Kintore to Tealing 400kV Overhead Line

Summary Report on Consultation - Alignment Selection

January 2025

Figure 9 - Proposed Alignment: Section A

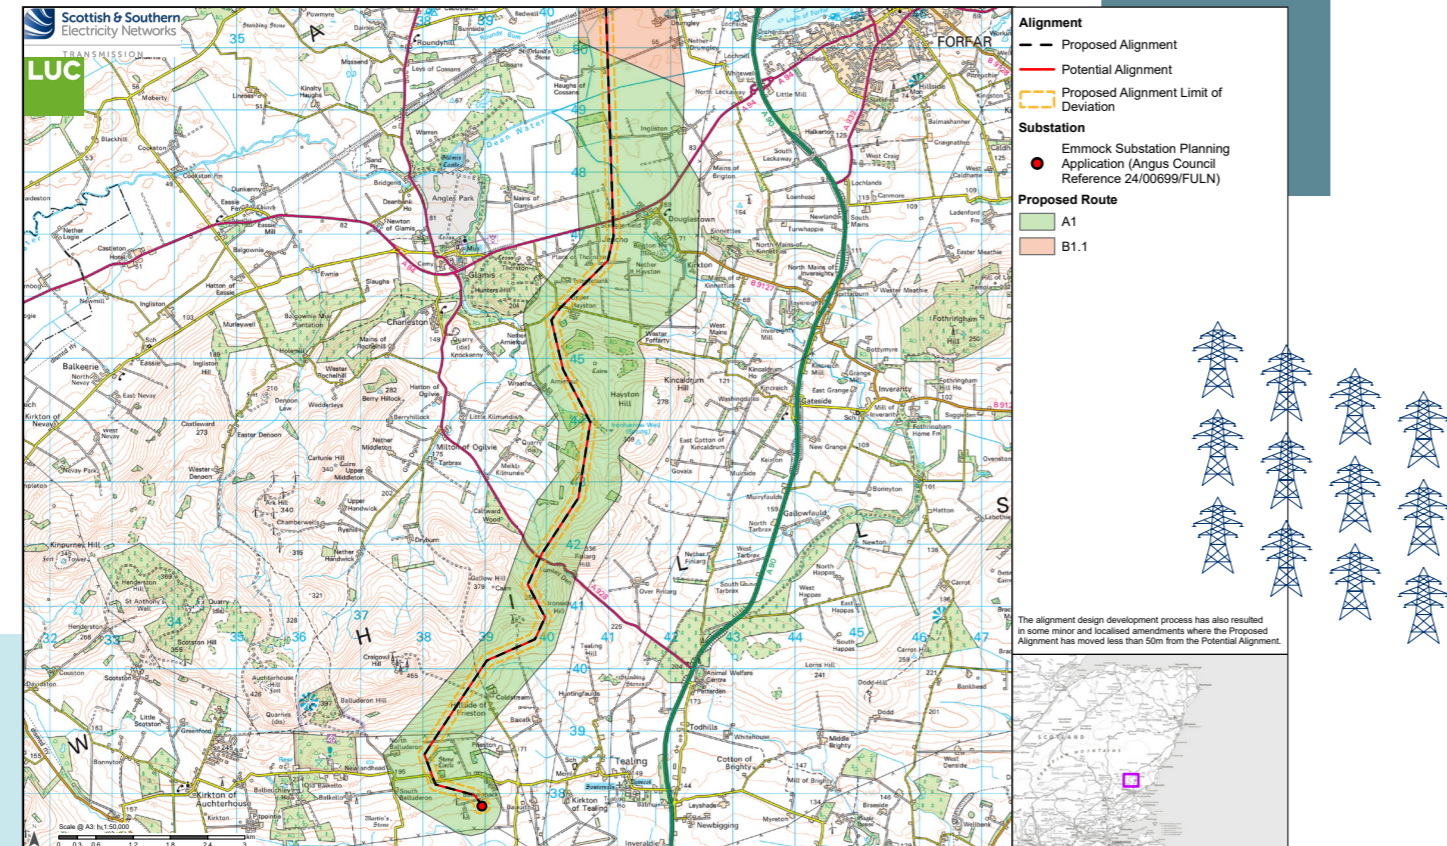
- Location: The overhead line was considered to have significant effects on the areas where people live. Suggestions were made that the overhead line should be moved further away from communities and homes.

- Landscape and visual: Concerns included the landscape and visual impact of the overhead line and towers on the area.
- Ecology: NatureScot noted potential impacts to specific designated areas e.g. the Firth of Tay and Eden Estuary Special Protection Area (SPA). Concerns raised by others related to impacts on migrating birds, bats and other wildlife, as well as habitats.

- Cultural heritage: Historic Environment Scotland (HES) and Aberdeenshire Council Archaeology Services (ACAS) noted a number of cultural heritage assets that may be impacted. Concerns raised by other respondents included impacts to local heritage such as ancient monuments near Tealing.

- Agriculture: Concerns were raised over the potential to damage farmland and impacts to farm animals given the amount of livestock in the area.
- Access: Concerns were raised about impacts of the project on roads including historic roads and roadside stone dykes and walls.

- Technical issues: Internet and phone services are considered to be poor in the area, and concerns were raised over the impact on internet and telecommunication services.

- Location: We have aimed to route the overhead line a target distance of 170m or more from residential properties and to maintain a minimum distance of 100m where possible taking account of other land uses.

- Landscape and visual: A landscape and visual impact assessment will be undertaken and reported in the Environmental Impact Assessment Report (EIAR), which will set out the measures to avoid, reduce and minimise landscape or visual impacts where possible.

- Ecology: Wherever possible, the alignment has avoided designated sites (such as SPA) and ensured that buffers and clearance areas are left between the project and designated sites to reduce impacts. The overhead line design has been developed to avoid and reduce impacts on habitats and species as far as possible. A full ecological assessment will be undertaken and reported in the EIAR setting out relevant mitigation proposals.

- Cultural heritage: Impacts to cultural heritage designations and interests will be assessed and reported in the EIAR, including any mitigation measures required.

- Agriculture: The alignment has been developed wherever possible to minimise effects on farms and farmland. We will continue to discuss access and construction arrangements with landowners to reduce disturbance.

- Access: Access to the project will avoid routes that could affect sensitive areas. Access is being developed working closely with landowners to minimise disruption.

- Technical issues: We are working closely with telecommunications operators to ensure that there will be no significant impacts from the project on telephone, internet and other communications infrastructure.

Having reviewed the consultation feedback for Section A, no significant changes to the Potential Alignment are proposed.

In Section A we will take the Potential Alignment forward for the Environmental Impact Assessment and detailed design as our Proposed Alignment, as shown in **Figure 9: Proposed Alignment - Section A**.

Figure 10 - Proposed Alignment for Location 1: Hayston Hill

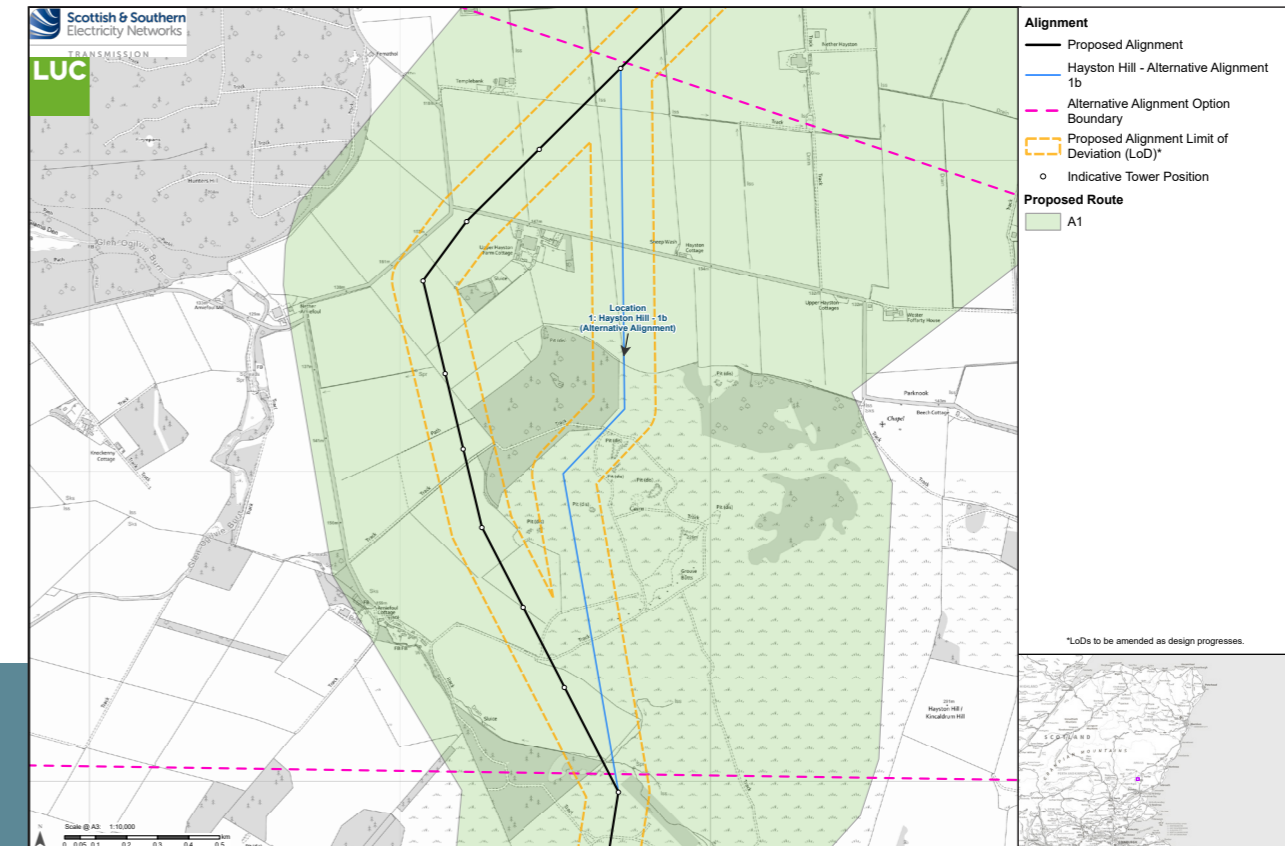
- A minority of respondents preferred **Potential Alignment 1a**. A key point raised was:
- Preference for Potential Alignment 1a as Alternative Alignment 1b was much closer to the scheduled monument at Arniefoul Cairn, as raised by HES and ACAS.

- The majority preferred **Alternative Alignment 1b**. Key points raised were:
- Angus Council noted Potential Alignment 1a may be closer to residential properties.

- Alternative Alignment 1b would better protect the unique character of the environment and would have less impact on ecosystems, people and local tourism businesses.

- Alternative Alignment 1b would be shorter, would have fewer impacts overall, would require less material and time to build and cause less access and road damage and disruption.

- Alternative Alignment 1b would have a lesser impact on agricultural land.
 - It was felt the Nether Arniefoul Unenclosed Settlement was considerably closer to Potential Alignment 1a than Alternative Alignment 1b.

- Alternative Alignment 1b would have less impact on watercourses and flood risk, and less impact on forestry.

- Proximity to property and the potential for adverse visual effects at locations such as Arniefoul and Hayston is considered to be similar for both alternatives and the alignment will be developed to target a separation distance of 170m or more from residential properties and to maintain a minimum distance of 100m where possible, taking account of other land uses.

- The Potential Alignment 1a provides greater opportunity to reduce landscape impacts by crossing areas that are less hilly.
 - Cultural heritage constraint is considered to be greater for Alternative Alignment 1b and any potential impacts on archaeology will be assessed and mitigated wherever possible in the EIAR.

- Alternative Alignment 1b would cross more extensive areas of upland hill land with more sensitive heath habitats. The alignment design will be developed to minimise woodland loss where possible and mitigation for any potential effects on water supplies will be set out in the EIAR.

- Alternative Alignment 1b is slightly shorter than the Potential Alignment 1a and is considered to have similar technical challenges, although it crosses more challenging ground conditions at higher altitude.

Having reviewed the consultation feedback for this alignment location, including statutory consultee responses, it is considered that Potential Alignment 1a remains less constrained overall in relation to the environmental and technical criteria appraised.

In this location we will take **Potential Alignment 1a** forward for the Environmental Impact Assessment and detailed design as our Proposed Alignment, as shown in **Figure 10: Proposed Alignment for Location 1: Hayston Hill**.

Figure 11 - Proposed Alignment: Section B

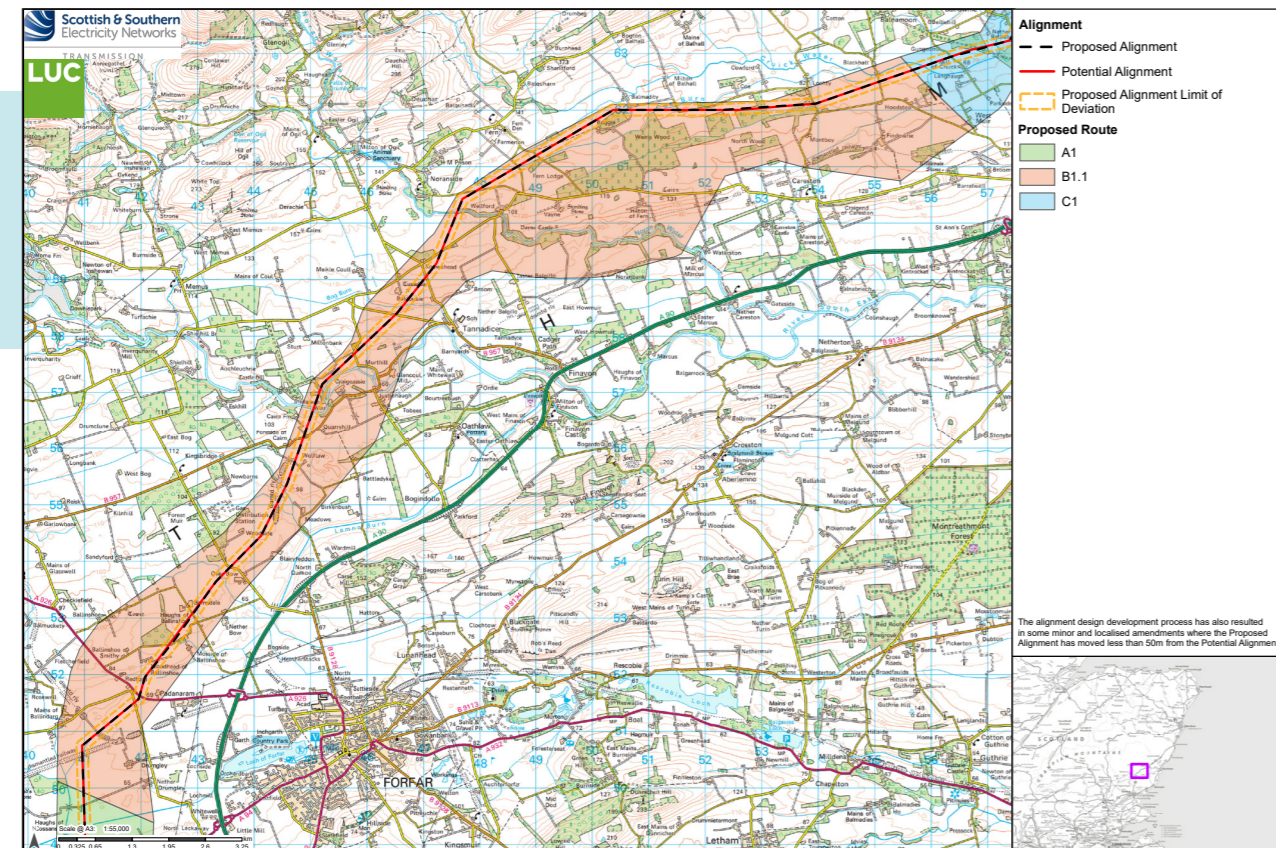
- Location: Some felt that some properties were missing from the mapping used in the Consultation Document (e.g. around Padanaram). The overhead line was considered to have significant effects on the areas where people live especially where there are already overhead lines in the area, with the suggestion that the new overhead line will create a 'wrap around' effect along with other overhead lines. Suggestions were made that the overhead line should be moved further away from communities.

- Ecology: Feedback highlighted concern about impacts on specific sites, e.g. Lochty Wood, Ancient Woodland, wetlands and protected species. The Esk District Salmon Fishery Board (DSFB) noted River South Esk salmon spawning grounds and fishing areas. The possibility of potential impacts on designated sites e.g. the Montrose Basin Site of Special Scientific Interest (SSSI), SPA and Ramsar site was raised by NatureScot.

- Cultural heritage: Feedback from HES and ACAS highlighted potential for setting impacts on specific sites, e.g. the Brown and White Caterthun hill forts, Battledykes Roman Camp. Local residents noted some local historical aspects, e.g. Lochty fields crop marks.

- Water resources: Concerns were raised by the Esk DSFB with regards to the potential risk of riverbank erosion and an increase of fine sediments in the River South Esk. Concerns were raised relating to the possible increase in the risk of flooding, noting a long history of flooding in the area.

- Access: Concerns were raised about the poor existing road conditions and single track roads. It was noted that many bridges are historic with traffic and weight restrictions. Road conditions and traffic management are felt to be currently under pressure across the area.

- Health: Concerns raised over the impact on health due to the proposed proximity of the overhead line to residents and schools.
- Agriculture: Concerns over the impact to farming practices (e.g. size of plant operating around overhead line and towers) access to fields, impacts on prime agricultural land, biosecurity issues and impacts on field drains.

- Technical issues: Concerns were raised over the possible impact to internet and telecommunication services from electromagnetic interference. The area is also used for low flying military aircraft. Potential impacts on the existing sewerage system were also identified.

- Location: With regard to properties not shown on our base mapping, the Ordnance Survey (OS) base maps we have used are the latest available, dated July 2024. We do not however rely on OS base maps to identify properties, and we use the latest versions of AddressBase data, which we overlay on our mapping systems. We also collect up to date aerial imagery to ensure we are including all properties. Our land teams are also on the ground liaising directly with landowners. A landscape and visual impact assessment will be undertaken and reported in the EIAR, it will consider existing overhead lines and set out relevant measures to avoid, reduce and minimise landscape or visual impacts.

- Ecology: Wherever possible, the alignment has avoided designated sites (such as SPA) and ensured that buffers and clearance areas are left between the project and designated sites to reduce impacts. The overhead line design has been developed to avoid and reduce impacts on habitats and species as far as possible. A full ecological assessment will be undertaken and reported in the EIAR setting out relevant mitigation proposals.

- Cultural heritage: Impacts to cultural heritage designations and interests will be assessed and reported in the EIAR, including any mitigation measures required.

- Water resources: We are liaising with the Scottish Environment Protection Agency (SEPA) and will undertake a full water resources and flood risk assessment which will be reported in the EIAR along with mitigation measures. Watercourses will be protected during construction.

Having reviewed the consultation feedback for Section B, no significant changes to the Potential Alignment are proposed.

In Section B we will take the Potential Alignment forward for the Environmental Impact Assessment and detailed design as our Proposed Alignment, as shown in **Figure 11: Proposed Alignment - Section B.**

- Access: We will undertake surveys of all roads and access points prior to construction and undertake a Traffic and Transport Assessment. Traffic will be carefully managed and road conditions will be monitored, photographed and repaired if damaged.

- Health: We have aimed to route the overhead line a target distance of 170m or more from residential properties and to maintain a minimum distance of 100m where possible taking account of other land uses.

- Agriculture: The alignment has been developed wherever possible to minimise effects on farms and farmland. We will continue to discuss access and construction arrangements to reduce disturbance.

- Technical issues: We are working closely with telecommunications operators to ensure that there will be no significant impacts from the project on telephone, internet and other communications infrastructure. We are also liaising with the Ministry of Defence and Scottish Water.

Figure 12 - Proposed Alignment for Location 2: Padanaram

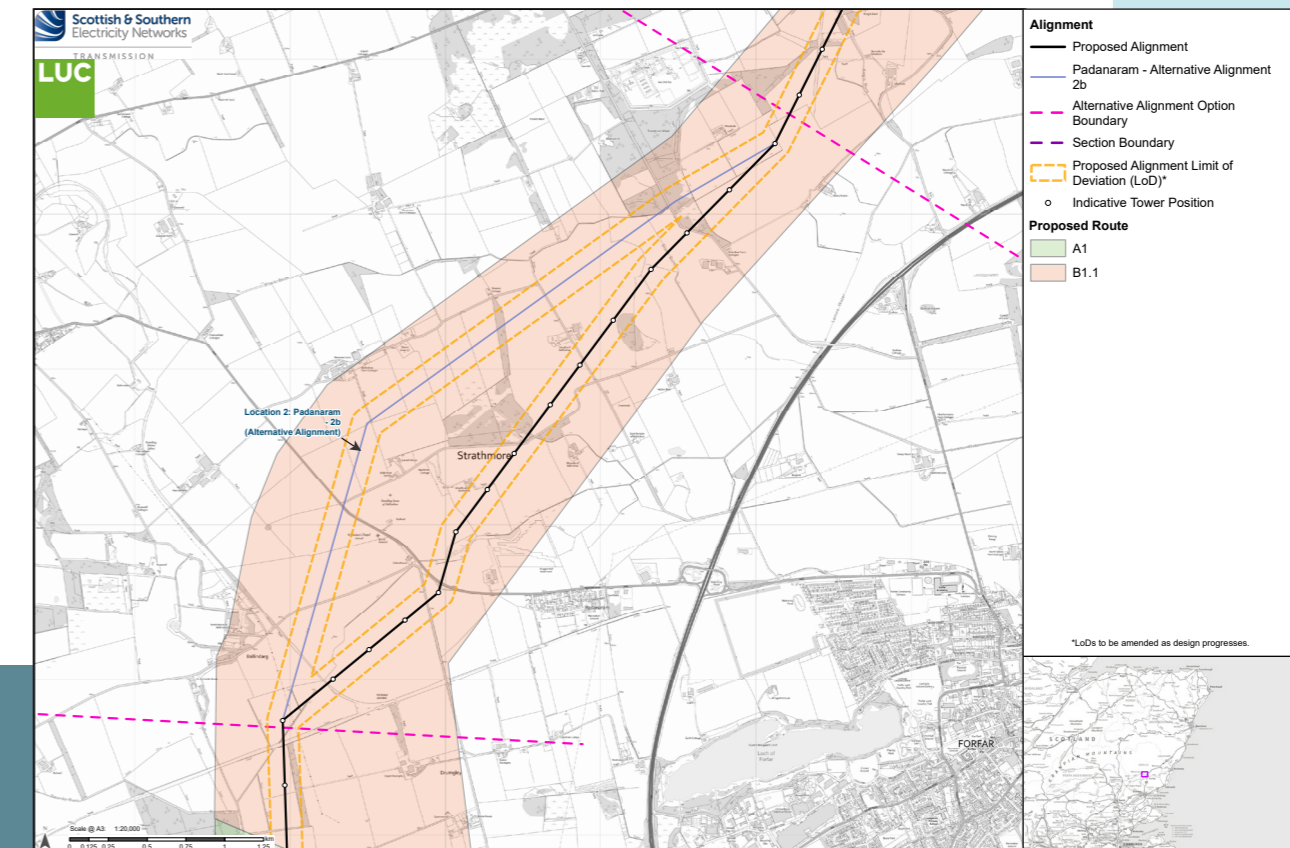
- Some felt that Potential Alignment 2a has an overhead line near it already and infrastructure should be kept together to minimise impacts elsewhere.
- It was felt that Alternative Alignment 2a would have less impact on telecommunications.
- Potential Alignment 2a would significantly reduce the impact on high quality agricultural farmland and farming operations.
- Concerns were raised by ACAS about the potential impact on the setting of cultural heritage features including Ballinshoe Castle, citing a preference for Potential Alignment 2a.

- Angus Council noted that Potential Alignment 2a could result in greater impacts on residential receptors north of Padanaram around Ballinshoe and to some residential and farm settings than Alternative Alignment 2b.

- Some residents of Padanaram were concerned that the existing overhead line near the village has not been considered in the assessments and residents would be over-exposed to the environmental, socio-economic and health effects from overhead lines, with noise noted as a particular issue from the existing overhead line.

- The route of the overhead line near Padanaram of Potential Alignment 2a would have a direct impact on migratory geese and swans.
- Alternative Alignment 2b significantly reduces the impact to farmland compared to Potential Alignment 2a.

- Potential Alignment 2a includes works to protect a gas main and would have more construction impacts than Alternative Alignment 2b.
- Some respondents, including Forfar Community Council, had a preference for Alternative Alignment 2b based on the fewer number of dwellings impacted and that it would be less impacted by flooding.

- Both alignments were developed to avoid the main settlement area at Padanaram.
- Proximity to property and potential for adverse visual amenity and related effects such as operational noise from the overhead line is considered to be similar for both alternatives. The overhead line will be developed to maintain a target separation distance of 170m or more from residential properties and to maintain a minimum distance of 100m where possible, taking account of other land uses. Constraint from farmland and areas at risk of flooding is not materially different between the two alternatives.
- Similarly, the level of constraint from migratory birds such as geese and swans was appraised as being comparable.
- Alternative Alignment 2b has been evaluated as being more technically constrained than the Potential Alignment 2a in relation to proximity to an adjacent high pressure gas pipeline.

Having reviewed the consultation feedback for this alignment location, including statutory consultee responses, it is considered that the Potential Alignment 2a remains less constrained overall in relation to the environmental and technical criteria appraised.

In this location we will take **Potential Alignment 2a** forward for the Environmental Impact Assessment and detailed design as shown in **Figure 12: Proposed Alignment for Location 2: Padanaram**.

Figure 13 - Proposed Alignment for Location 3: Justinhaugh

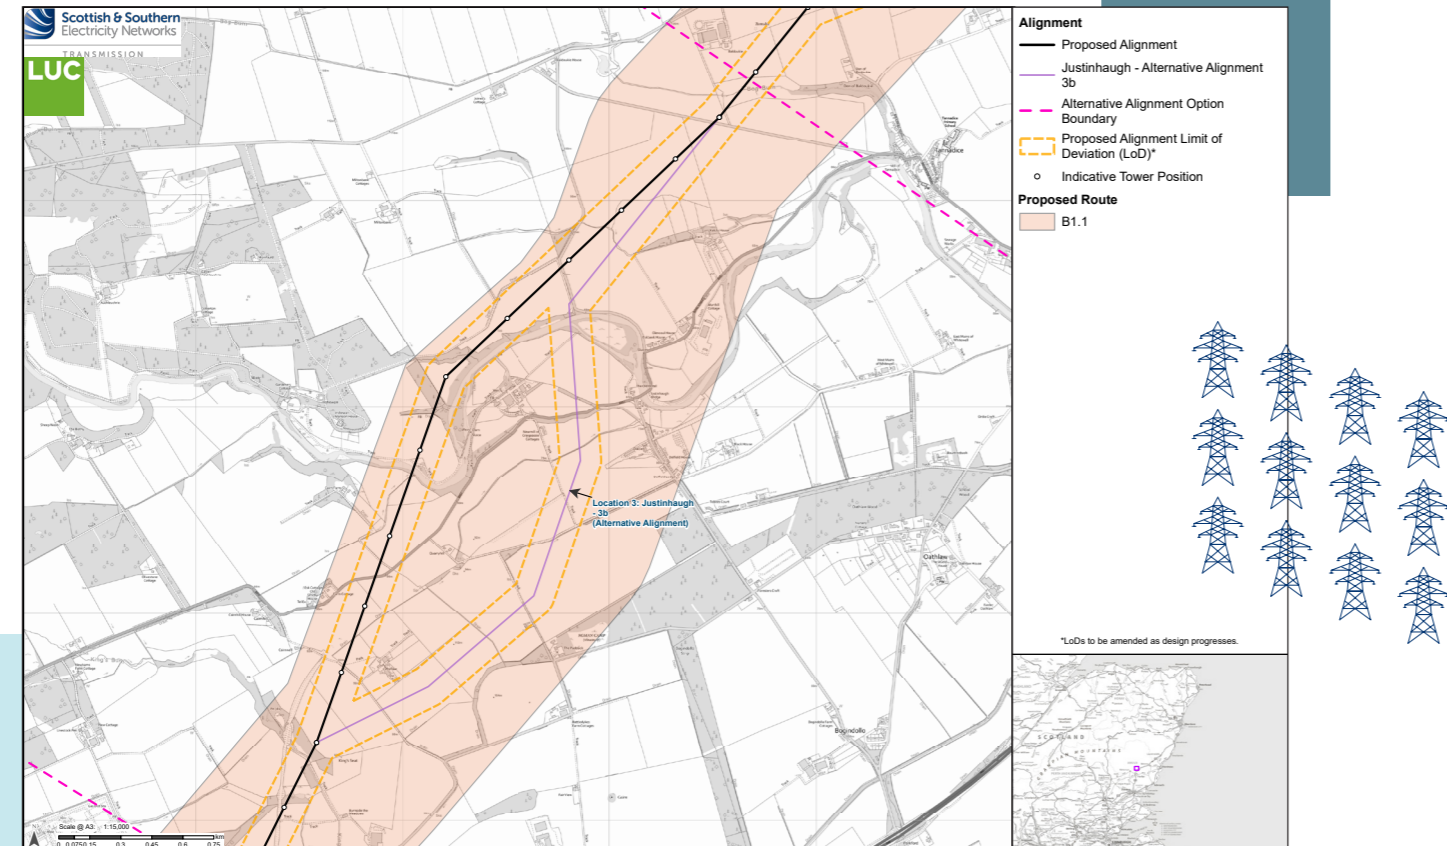
- Some respondents preferred **Potential Alignment 3a**. Key points raised were:
- Any overhead line along Alternative Alignment 3b would be seen from the A90 and nearby houses, this was not the case with Potential Alignment 3a.

- Concerns were raised from ACAS regarding the potential to impact cultural heritage features including Battledykes Roman Camp and Battledykes Cairn, and respondents noted a preference for Potential Alignment 3a.

- The crossing of the river by Alternative Alignment 3b was raised as a concern due to flooding issues.
 - Particular concerns were raised about the unsuitability of local roads for access, Potential Alignment 3a was considered to be more suitable.

- It was judged by some that Alternative Alignment 3b would have adverse detrimental impacts on farmland and residential properties, with Potential Alignment 3a preferred.

- Some preferred **Alternative Alignment 3b**. Key points raised were:
- Respondents felt that fewer homes would be impacted by Alternative Alignment 3b. It was felt that noise impacts from the overhead line during operation could not be mitigated and that SSEN Transmission's target to site the overhead line no closer than 170m from homes could not be met on Potential Alignment 3a.

- Visual impact on viewpoints in the area of Potential Alignment 3a would be significant; of note would be the impact on the view north to the Glens across the River South Esk. Alternative Alignment 3b would be less detrimental.

- Concerns were raised relating to the crossing of the River South Esk by Potential Alignment 3a, particularly in relation to aquatic ecology, salmon spawning, fishing areas and osprey nesting.

- Proximity to property is considered to be similar for both alternatives and the overhead line will be developed to maintain a target separation distance of at least 170m or more from residential properties and to maintain a minimum distance of 100m where possible, taking account of other land uses.

- There is potential for adverse effects on views and visual amenity from some properties adjacent to both alternatives and these will be assessed further in the EIAR. Alternative Alignment 3b crosses a pronounced area of raised ground north-west of Battledykes which was considered to have particular landscape and visual impacts compared with the Potential Alignment 3a.

- Both alternatives cross the River South Esk which formed a key part of the appraisal of several environmental criteria. The Potential Alignment 3a would span the river and its flood plain with less impact on surface and groundwaters and less potential to impact on the ecological designation compared with the Alternative Alignment 3b.

- Potential Alignment 3a includes some tower locations which involve more challenging topography; however, overall it has been evaluated as being less technically constrained overall than Alternative Alignment 3b.

Having reviewed consultation feedback for this alignment location, including statutory consultee views, on balance it is considered that Potential Alignment 3a remains less constrained overall in relation to the environmental and technical criteria appraised.

In this location we will take **Potential Alignment 3a** forward for the Environmental Impact Assessment and detailed design as our Proposed Alignment, as shown in **Figure 13: Proposed Alignment for Location 3: Justinhaugh**.
